Number: A61-0263-00

SAFETY ALERT

Ride: YO YO

Subject: Lap Bar Kit

Components of Kit No. K61-0263-00

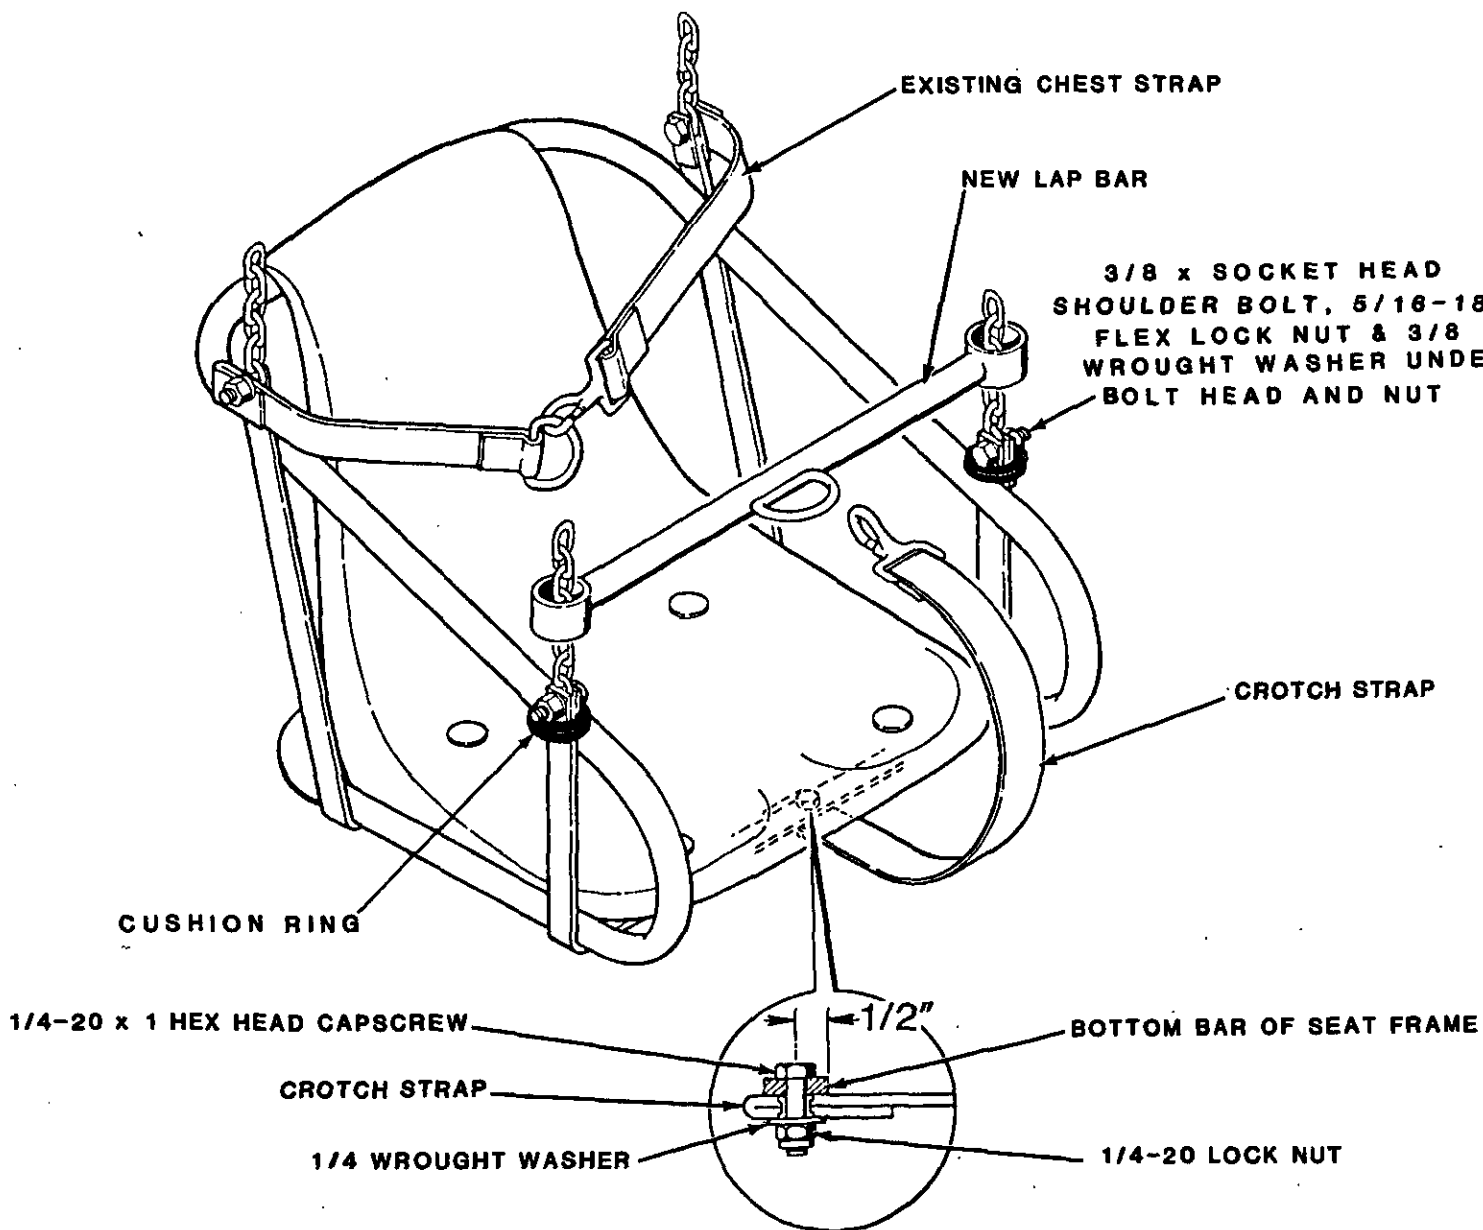
CHANCE MANUFACTURING has developed a new lap bar which increases passenger safety. The new lap bar design incorporates a crotch strap, which secures the lap bar in the lowered position. The existing chest strap must be used in conjunction with the new lap bar to complete the passenger restraint system.

ALL OWNERS OF YO YO RIDES ARE REQUIRED TO REPLACE THE EXISTING LAP BARS WITH THE NEW LAP BAR SYSTEM.

Order kit number K61-0263-00, which includes the new style lap bars, crotch straps and all necessary hardware for one complete ride (32 seats). Install the kit using the instructions on the reverse side of this bulletin. Fill out and return the attached Certification of Compliance for installation of the kit within seven (7) days from receipt of the kit.

1. With the ride stopped and the master circuit breaker in the "OFF" position, remove the two front chains from any seat. Remove the lap bar.
2. ~~Inspect all four chains for wear per Service Bulletin B61-0265-00.~~
3. Install a cushion ring over each front upright on the seat frame.
4. Install the new lap bar on the chains with the D-ring toward the front of the seat. Install the new hardware with the bolts pointing out from the seat as shown. Torque the nuts to 13 lb-ft.
5. Drill a 1/4-inch hole through the bottom bar on the seat frame, on the centerline of the seat as shown. Be careful not to drill into the plastic seat.
6. Install the crotch strap and hardware as shown. Torque the nut to 72 lb-in.
7. Repeat Steps 1 through 5 on all remaining seats.
